<b>Site Visit Report</b>	Project: <b>Faizabad Park Construction</b>
Location: <b>Faizabad, Badakhshan Province</b>	Coordinates: Latitude: <b>N 37°6'49.890"</b> Longitude: <b>E 70°34'42.660"</b>
Inspection Date: <b>November 16, 2013</b>	Weather: <b>Sunny, Temp @ 5°C, No Precipitation</b>
Inspectors: [REDACTED]	Status: <b>Incomplete</b>

**Work Order WO-LT-0009 AMD #5**

**EXECUTIVE SUMMARY**

**Figure 5.** Eastern stone masonry boundary wall

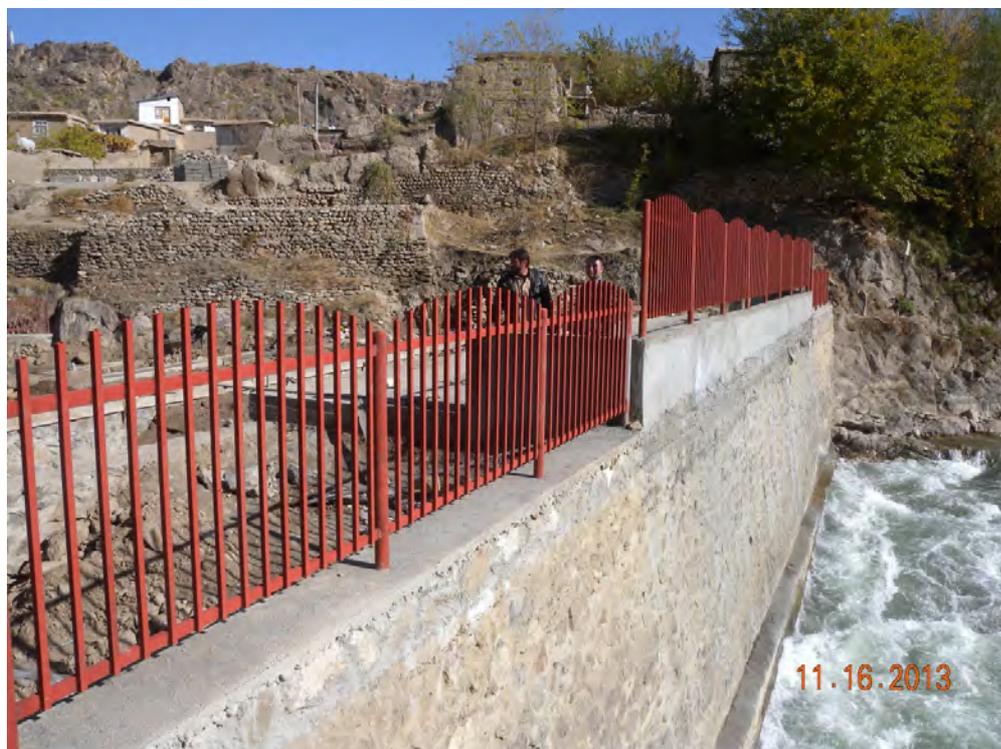
8. Construction of the entire stone masonry boundary wall and fence installation is incomplete. (Figures 4, 5, 6, 7, 8 and 9)
  - a. **Remaining work:** The contractor is required to paint the fence over the stone masonry boundary walls and fill the expansion joints (placed at each 12 meter length of the stone masonry boundary wall).
9. Installation of main entrance gate is incomplete. (Figure 3)
  - a. **Remaining work:** The contractor is required to paint the main entrance gate.
